Okahu & Puhoi Viaducts Deck System Review

27 March 2020

Deck System Review

Temporary Reinforcement Trusses

Photo 5: Deck panel in the process of being tied and

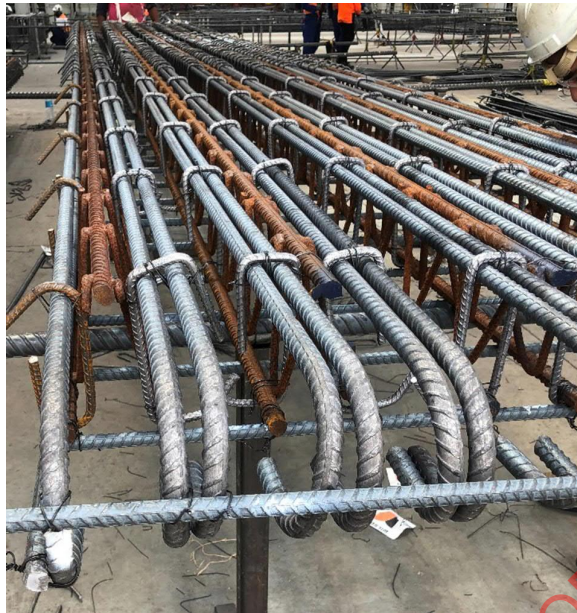
Fatigue fracturing of the TRTs is most likely to occur first at points of high bending moment; that is in the top chords over the girders and in the bottom chords between the girders where stress ranges are greatest. The initial stiffness of these relatively thin decks is governed by the unfractured TRTs and the permanent reinforcement. **Photo 5.** shows the extent of reinforcement within the deck panels made up with the TRTs (shown rusted) and the permanent reinforcement (shown grey). At points of TRT chord fracture there will be points of sudden change in deck stiffness.

The permanent deck is therefore expected to behave like a series of stiffer links connected by less stiff connections at points where bending moment is highest. The higher strains associated with the sharper deck curvature will cause cracking in the deck cover concrete. That is to top cover concrete above the girders and the bottom cover concrete between the girders.

Further cyclic traffic loading will also result in the fractured TRT chords 'working' within the deck creating cavities for moisture to collect. This could cause premature corrosion of all the reinforcement within the deck close to these locations.

3. That the bridge designer reviews their design to consider the effect of incorporating the TRTs into the permanent deck. This should include the potential fatigue failure mechanism identified in Section 3 in relation to long term deck performance and durability.
